CITY OF ALBUQUERQUE

RE: 7505 Laster Ave NE
Grading & Drainage Plan
Engineer's Stamp Date: 8/11/25
Hydrology File: D19D001B1
Case # HYDR-2025-00288

Based upon the information provided in your submittal received 08/11/2025, the Grading & Drainage Plan is approved for Building Permit and Grading Permit. Please attach a copy of this approved plan in the construction sets for Building Permit processing along with a copy of this letter. Please note that a Pad Certification is not required for this site.

ENGINEER'S SEAL	LOT 43 P-1 PALOMAS PARK 7505 LASTER AVE NE	DRAWN BY DEM
DAVID SOULE 14522 PROFESSIONAL ENGINEER	GRADING AND DRAINAGE PLAN	DATE 8-9-25
8/11/25	Rio Grande Engineering	7505 Laster Ave NE.dwg
DAVID SOULE P.E. #14522		SHEET # C1
		JOB #

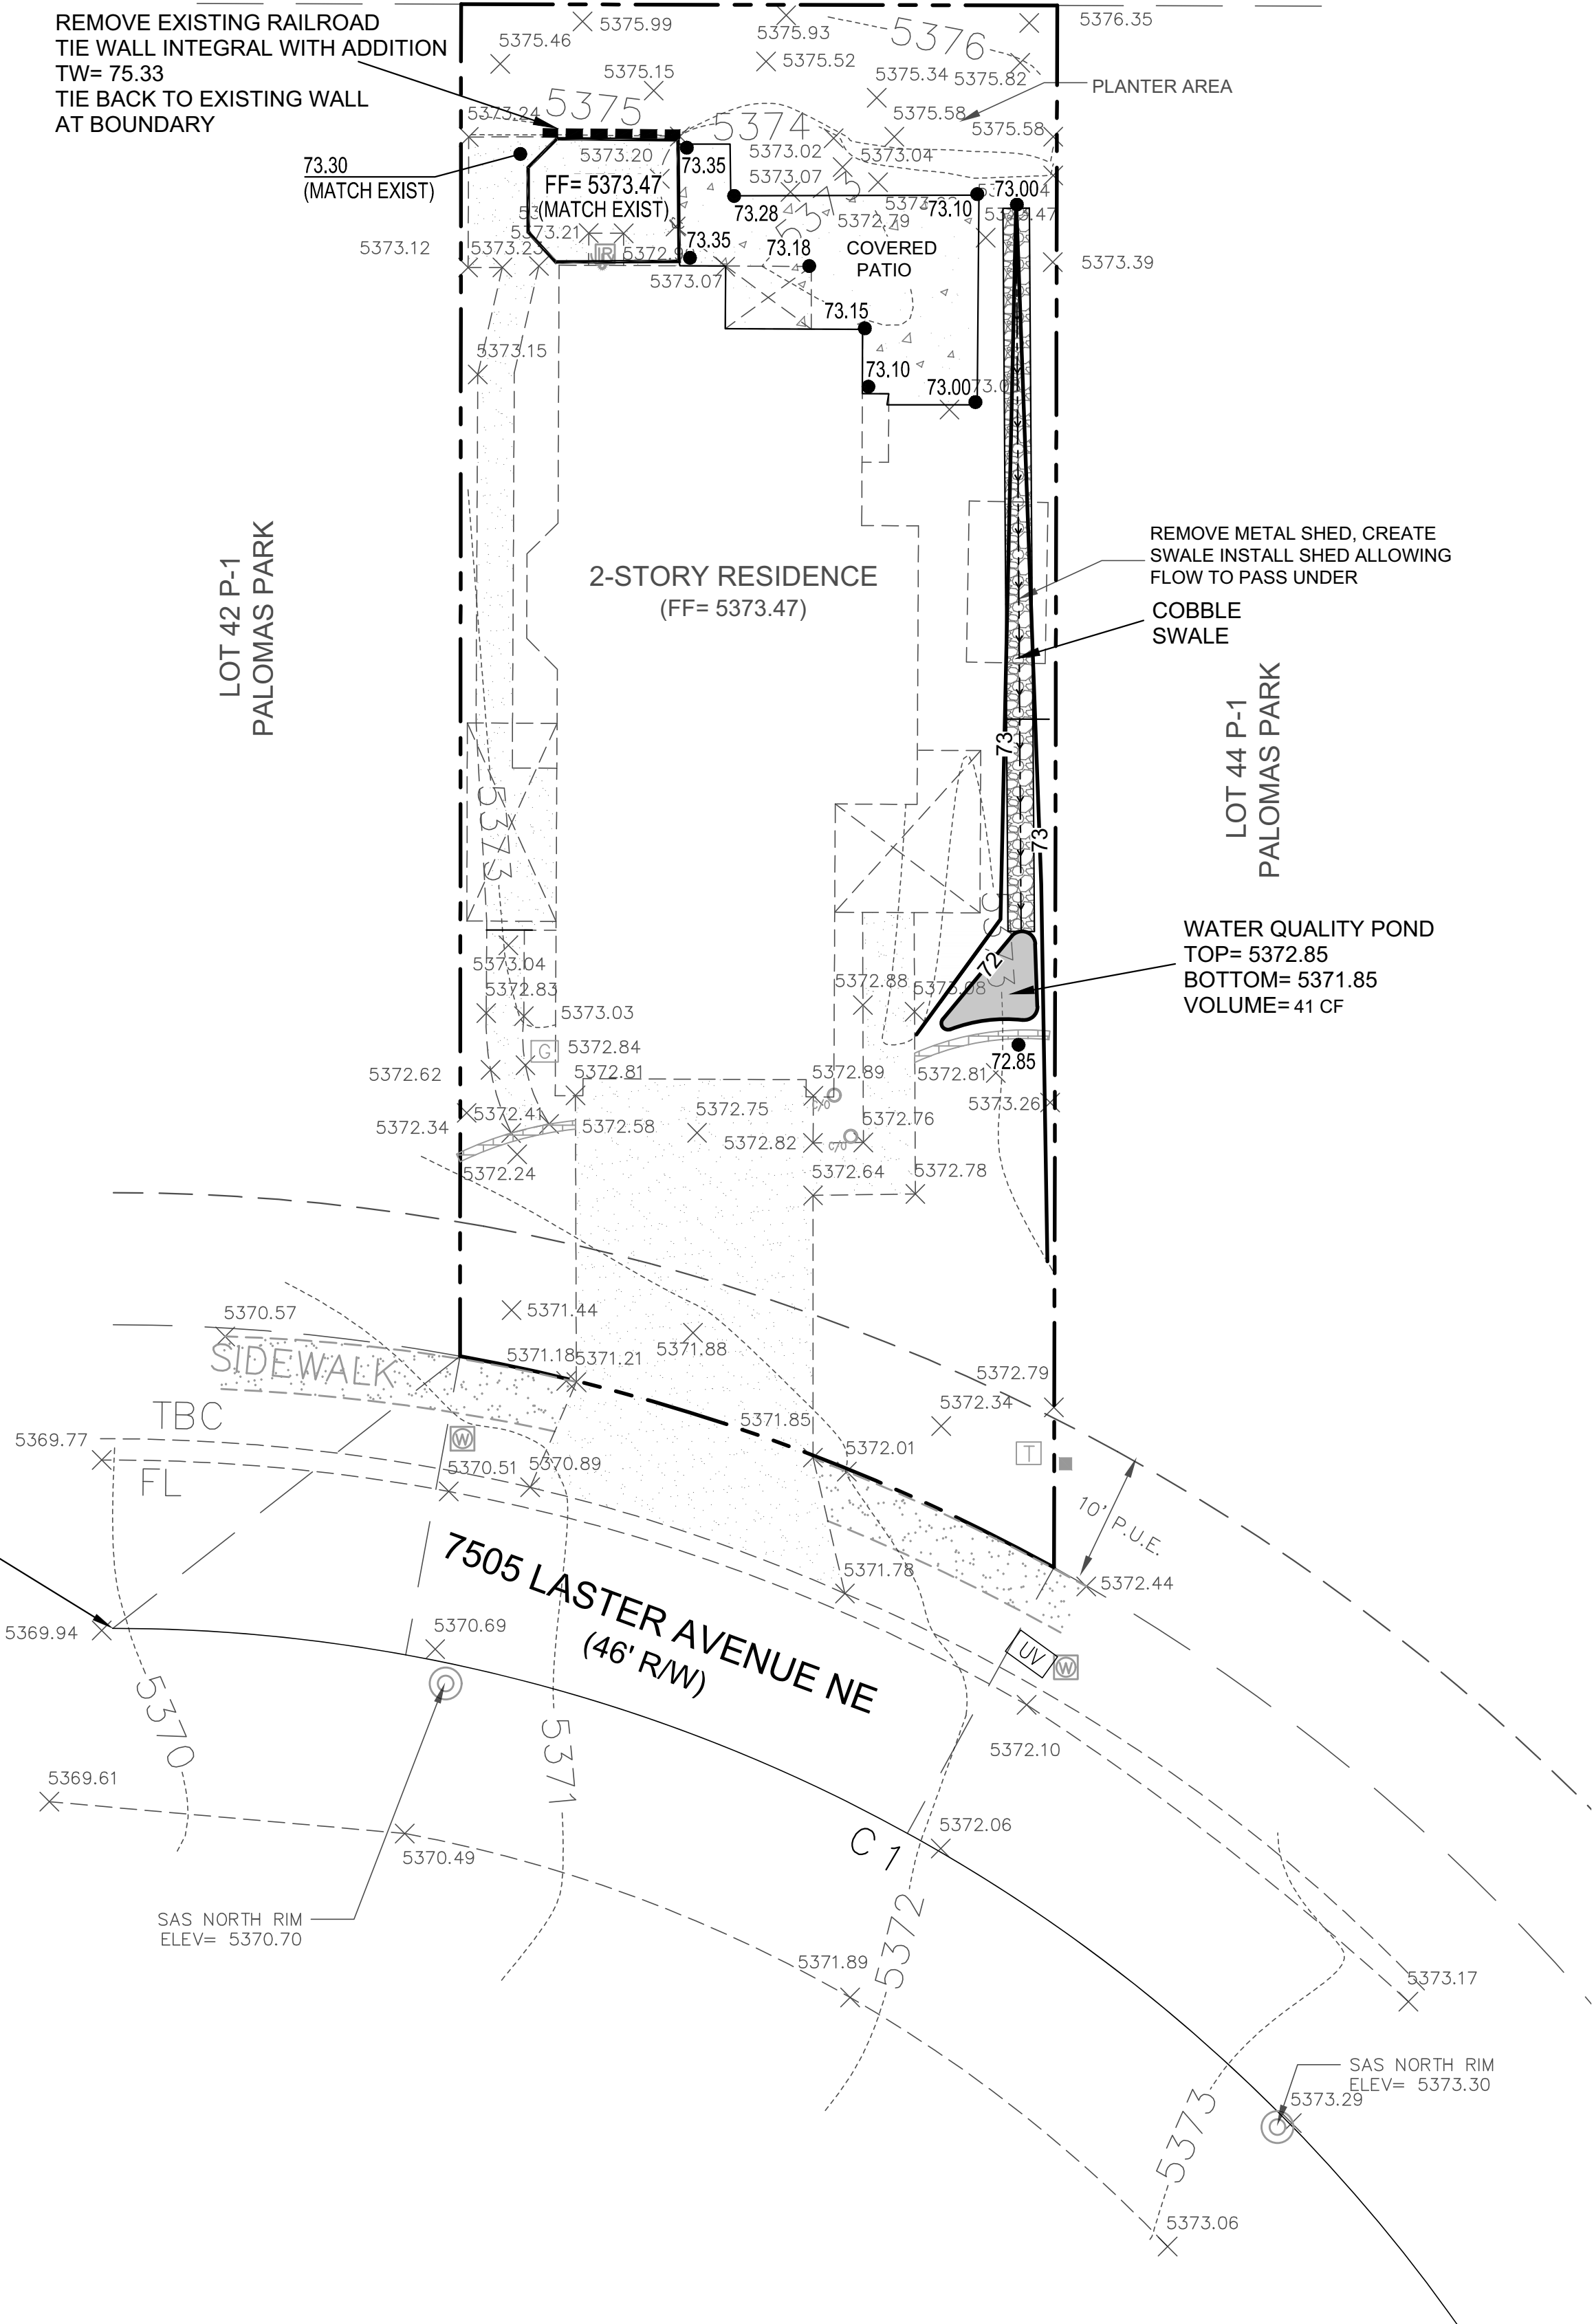
1. Engineer's Certification, per the DPM Part 6-14 (F): *Engineer's Certification Checklist For Non-Subdivision* is required.
